ALERT SERVICE BULLETIN

407-22-127

Revision A, 9 November 2022

SUBJECT: FREEWHEEL ASSEMBLY AFT CAP 406-040-509-101, INSPECTION OF.

Figure 1 – Location of Freewheel Assembly Aft Cap Serial Number

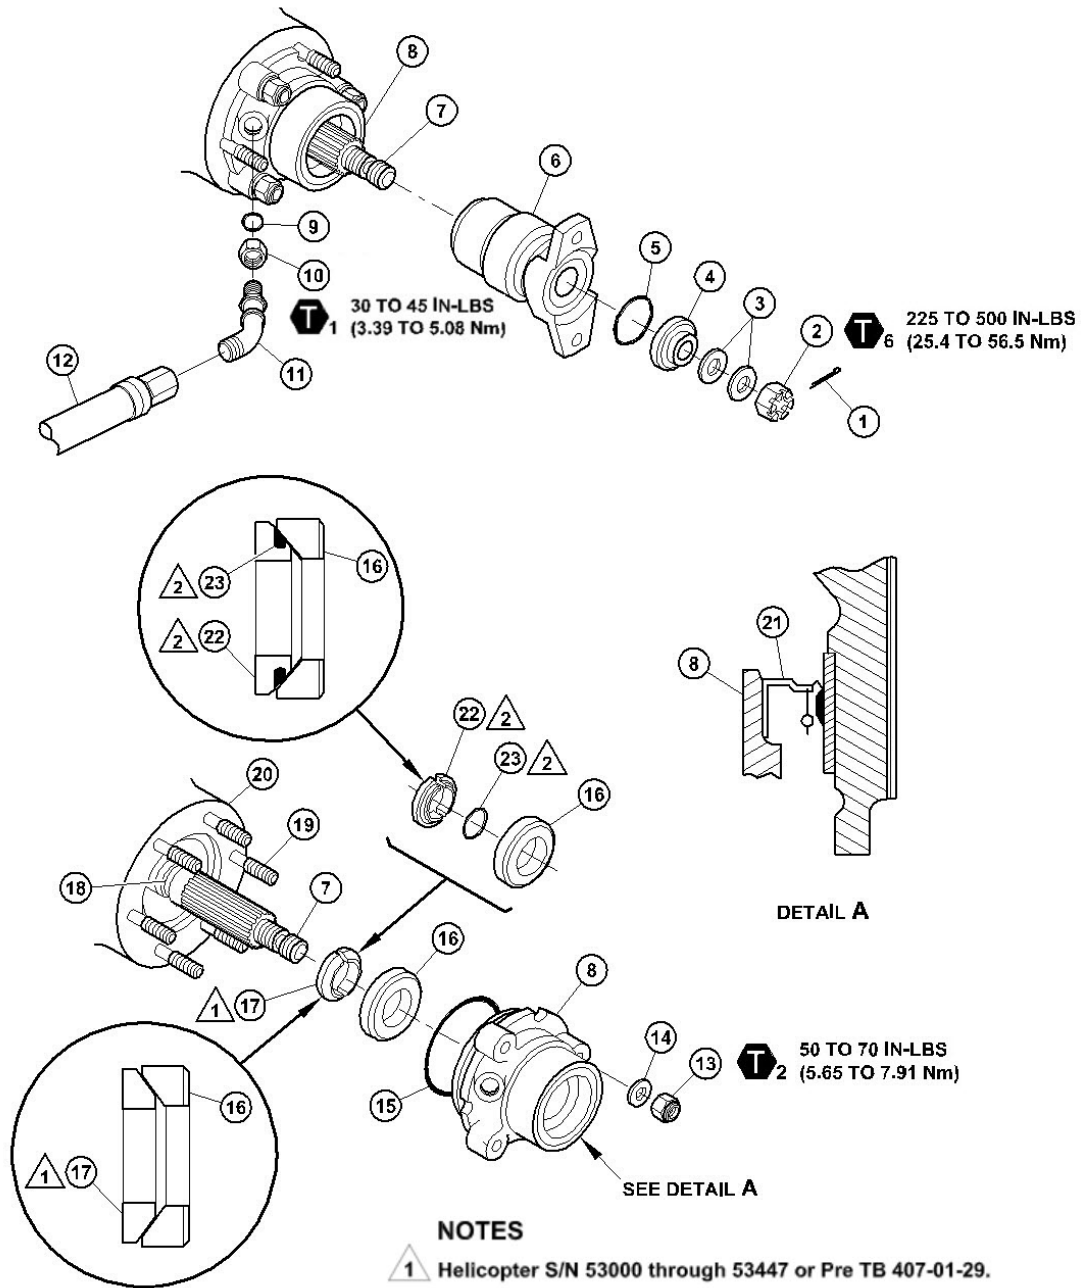
1. Prepare the helicopter for maintenance.
2. Gain access to engine bay area.
3. Verify serial number of the aft cap. It will be located under the part number (Figure 1).
 - a. If the aft cap serial number **is not** included in the **Table 1**, no further action is required, and go to step 4.
 - b. If the aft cap serial number **is** in the list in **Table 1**, perform **PART II** of this bulletin within the **COMPLIANCE** period.
4. Make an entry in the helicopter logbook and historical service records indicating compliance with **PART I** of this Alert Service Bulletin.

Figure 3 – Improper Machining of Aft Cap Scallop (sheet 1 of 2)

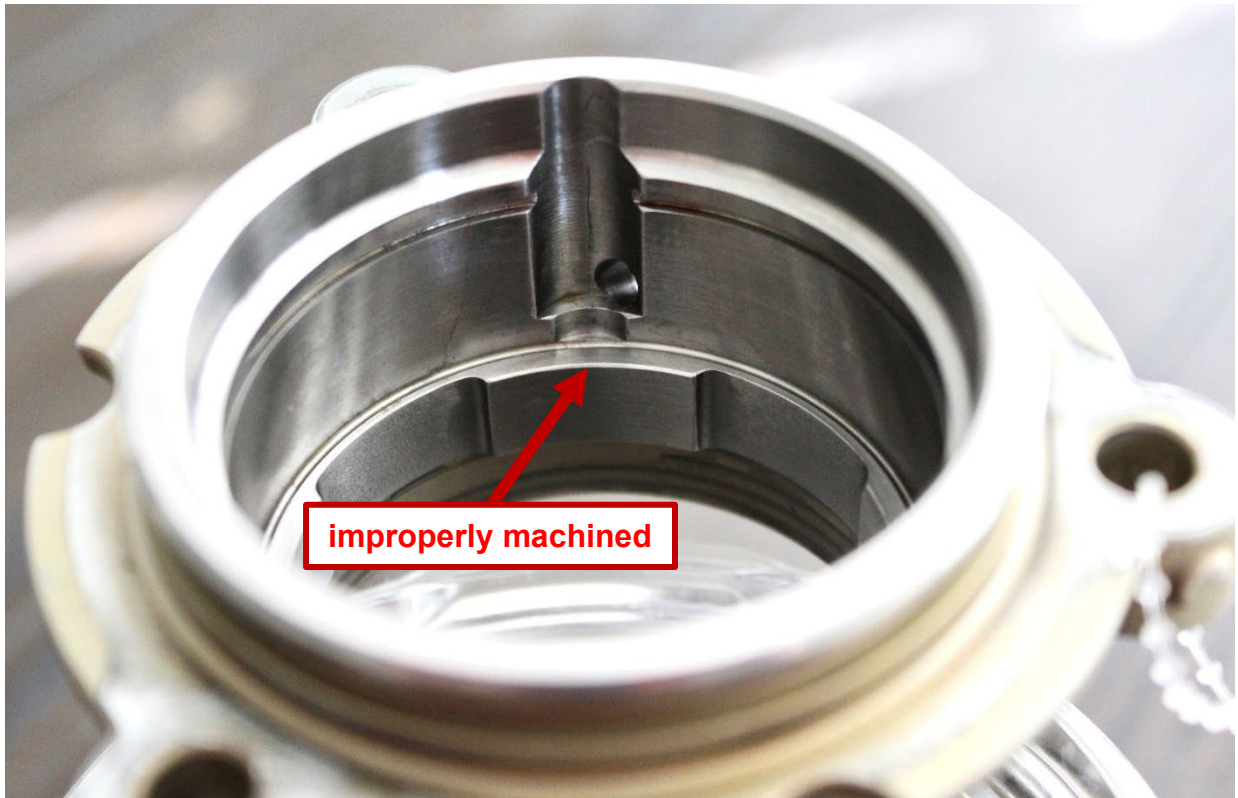
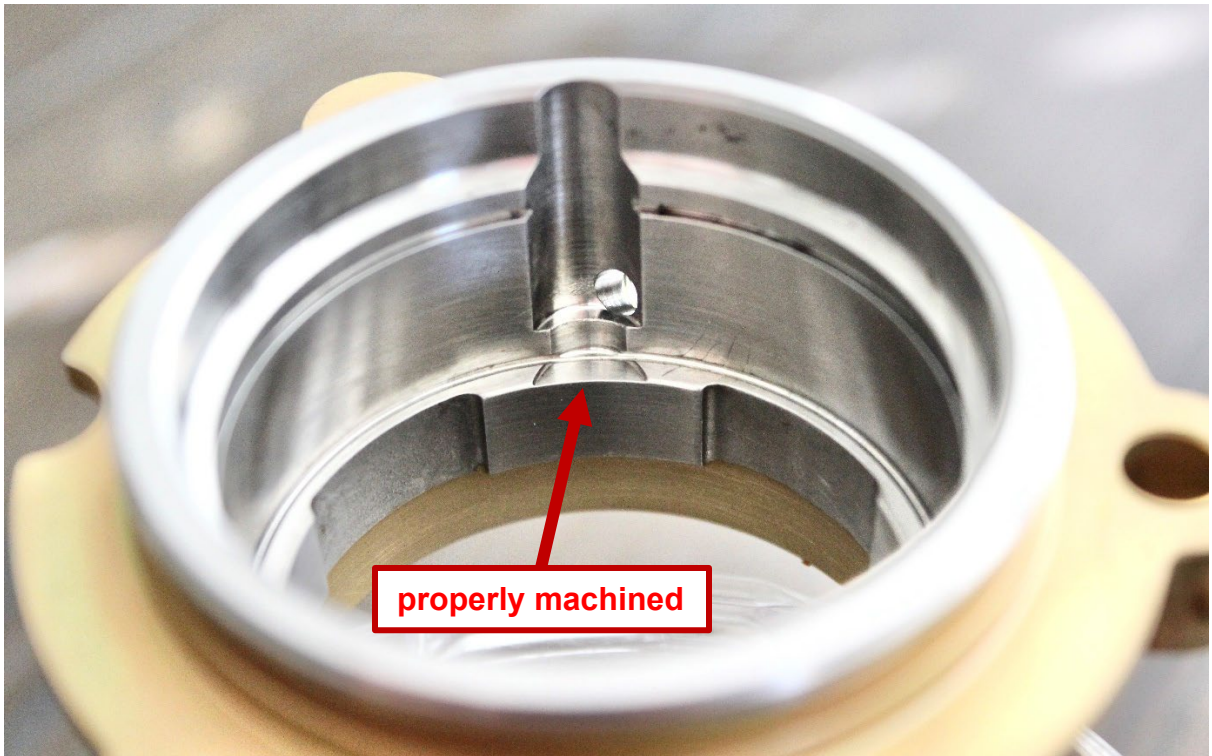
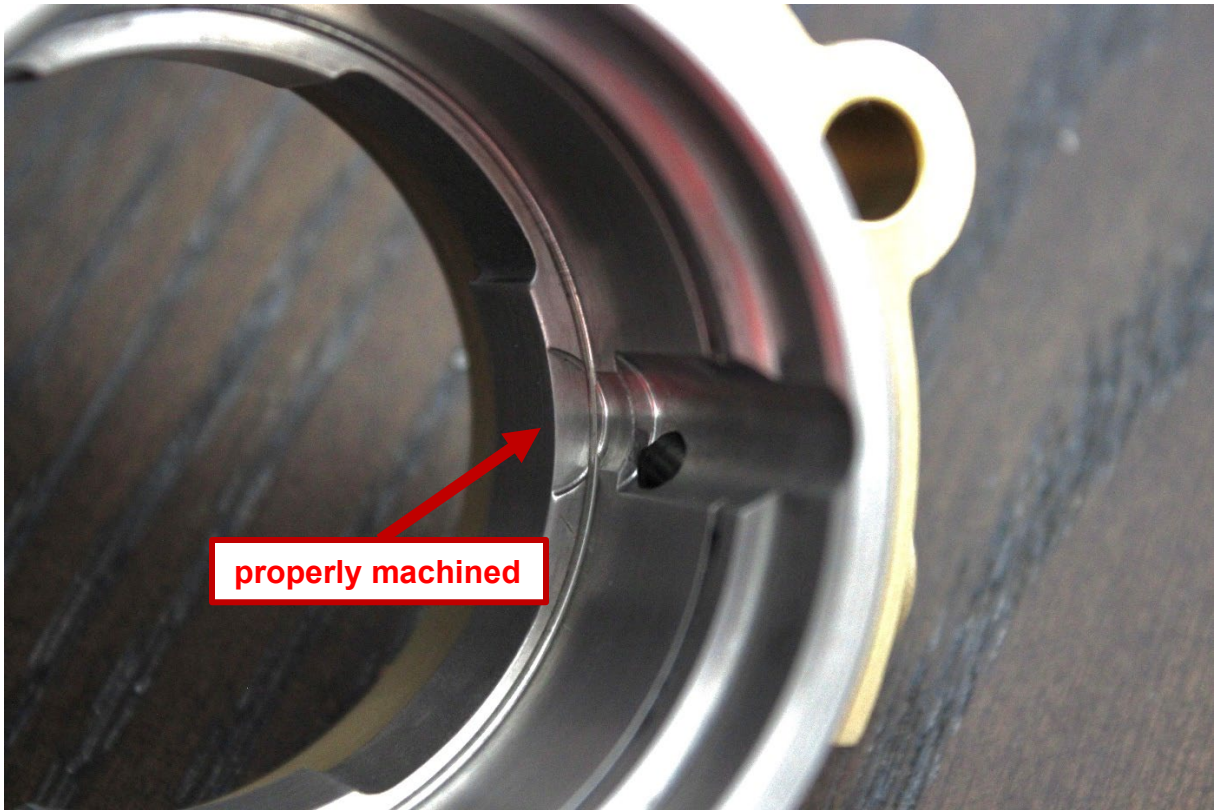
Bell has been made aware of a quality escape in the manufacturing process of the freewheel assembly aft cap 406-040-509-101. Some aft caps may have improperly machined scallops that are designed to allow oil to flow between the aft face of the support assembly bearing and the aft cap seal.

5. Inspect the freewheel assembly aft cap for a correctly machined scallop (Figure 3).
 - a. If the aft cap is correctly machined, go to step 10.
 - b. If the aft cap is **not** correctly machined, go to step 6.

6. Remove the elbow (11, Figure 2), nut (10), and preformed packing (9) from the freewheel support assembly (8).
7. Replace aft cap (8) with a serviceable cap that meets the intent of this bulletin.

- a. If there is no seal installed on the replacement aft cap, install seal (21) ([DMC-407-A-63-13-01-00A-720A-A](#)).
8. Inspect support assembly bearing ([DMC-407-A-63-13-02-00A-280A-A](#)). Replace if unserviceable.
